1 What is new in CKC V2.0?

Release: 01/2023

1.1 New component type for BMS machines

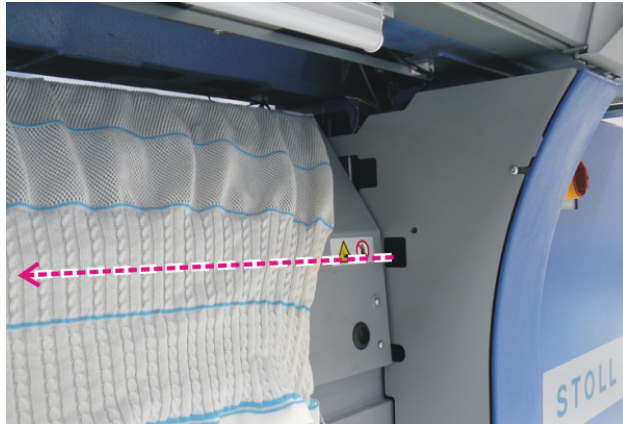
The changes in detail:

Holding-down jack (E14)	<p>An improved holding-down jack will be used.</p> <p>ⓘ Check the values for the holding-down jacks when you produce an existing knitting program again (PSV, PS^).</p>
Needle detector	<p>Up to now there was only a needle detector on the front carriage.</p> <p>Now there is a needle detector on the front and back carriage.</p>
Security strip at the needle bed	<p>Up to now you had to loosen both screws with a screwdriver to be able to move the strip.</p> <p>Now you can move the strip with the extraction hook.</p>
